Technical Requirements for Large Computational Loads in Ontario's Power System

Fang Gao

Lead Power System Engineer, Connection Assessments, IESO

New Requirements, Feedback, and IESO Responses

Connection Arrangement – Feedback and Response (1)

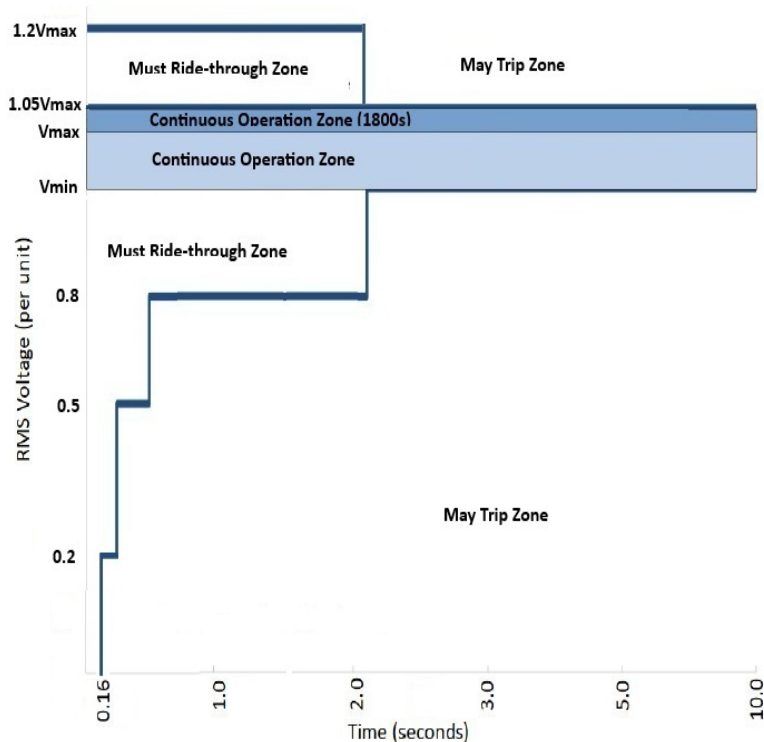
It is suggested to remove data centre load from load security requirements as the loss of this load would only impact on one customer and not a broader load interruption, which is the basis for the 600MW limit. The amount of interrupted load allowed following an internal fault shall be based on system impact.

- This requirement is not intended for load security purposes. It is intended to mitigate broader reliability impacts that may result from an internal fault at a large computational load facility. A limit of 600 MW is adopted as this is the maximum allowable load loss associated with a system event in our system.
- The IESO has evaluated various values for the maximum load loss limit and concluded that a 600 MW threshold provides a practical and technically justified balance. This is aligned with best utility practice here in Ontario.
- Where a project cannot meet this threshold, a different value may be considered subject to IESO review and approval through the System Impact Assessment process.

Voltage Ride-through (Enhanced) – Revised Graph

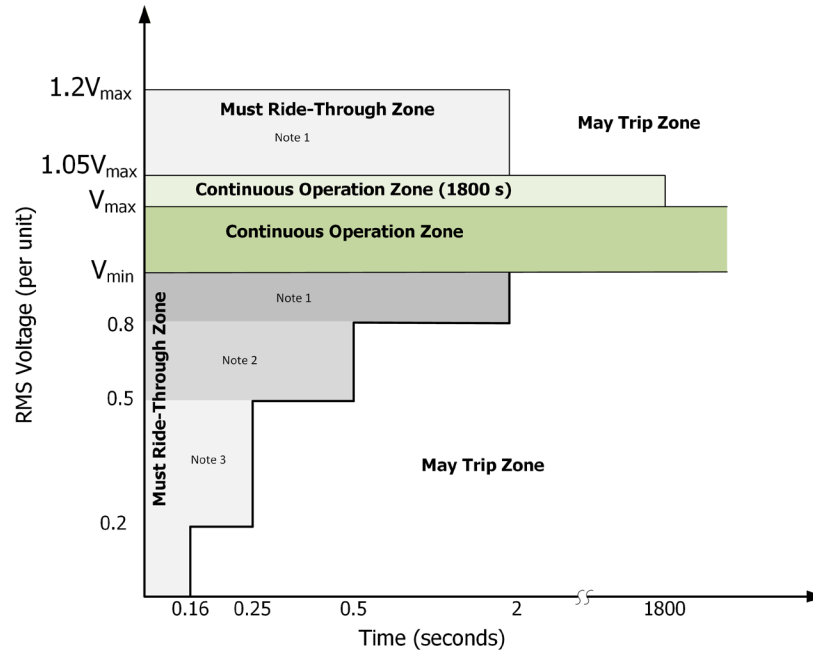
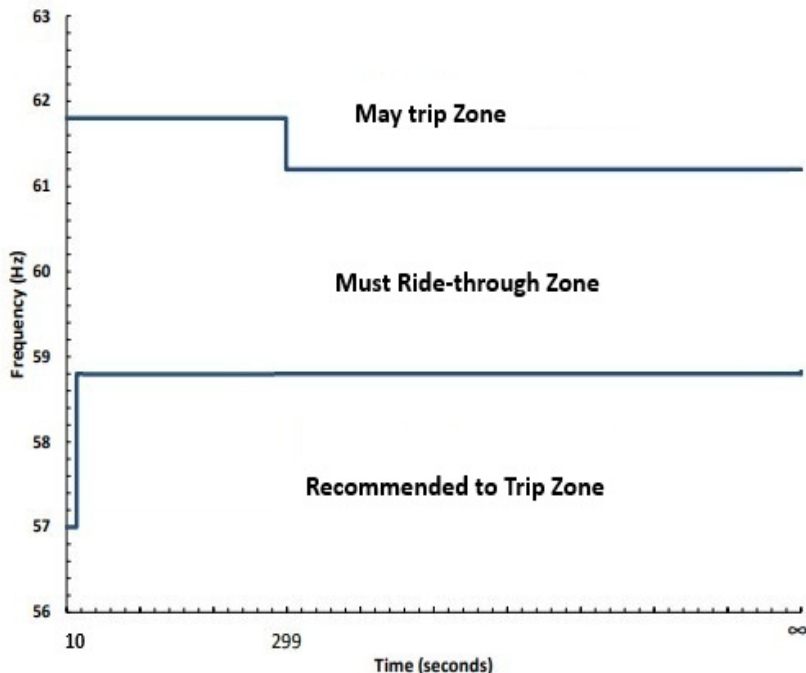
The UPS that could meet the following two requirements are not commercially available:

- Reduce active power proportionally to voltage during a 0.5–0.8 pu sag while remaining connected, and
- After voltage recovers, restore active power to the pre-disturbance level within 1 second.

Suggest to use a phased implementation approach like ERCOT.

Cooling or mechanical load is commonly 20–40% of total facility power and consists predominantly of induction motors. Induction motors below approximately 0.7 pu input voltage enter unstable regions of their torque-speed characteristic and risk stall, with consequential mechanical damage. This is a physical limit of the motor. It is recommended the IESO permit cooling or mechanical load trip when voltage conditions are below 0.35 pu like ERCOT.

The 1-second recovery window is an aggressive approach, and therefore requests clarification as to whether restoration should be staged rather than introducing a large load to the system all at once. The necessity of a staged approach is dependent on the project size. If not, why not?

The VRT may require ride-through of transient over-voltage up to 2 per unit as defined in Appendix 2 of TSC.

- There are no inherent equipment limitations for implementation of these requirements.
- ERCOT is using a phased implementation approach, with mandatory compliance taking effect on January 1, 2028. Given that only a limited number of LCL projects are expected to be in service in Ontario before that date, the IESO has determined that an interim exemption period, like the one adopted by ERCOT, is not necessary.

- The IESO recognize that small motors serving cooling and mechanical loads may need to be tripped when the POI voltage falls below 0.35 pu.
- The IESO has updated the requirement to include that due consideration will be given to inherent limitations of small motors for non-UPS cooling and mechanical loads which are allowed to be tripped when POI voltage goes below 0.35 pu. However, tripping these small motors shall not restrict the operation or delay the restoration of other IT loads after the system disturbance.

- The staged recovery is not necessary. Fast restoration of the load without ramp-rate limitations is required to balance the post-fault demand and generation in the system.
- The SIA may require different recovery timelines for individual projects.

The 2 per unit value specified in Appendix 2 of the TSC refers to equipment capability to withstand capacitor switching surges, not from system reliability perspective.

Note 1: UPS loads shall not reduce active power consumption from the system. They should not start switching to UPS supply.
Note 2: UPS loads can reduce active power consumption from the system only to a level proportional to voltage sag at POI. Partial load may switch to UPS supply.
Note 3: UPS loads may cease to withdraw active power from the system and full load can switch to UPS supply.
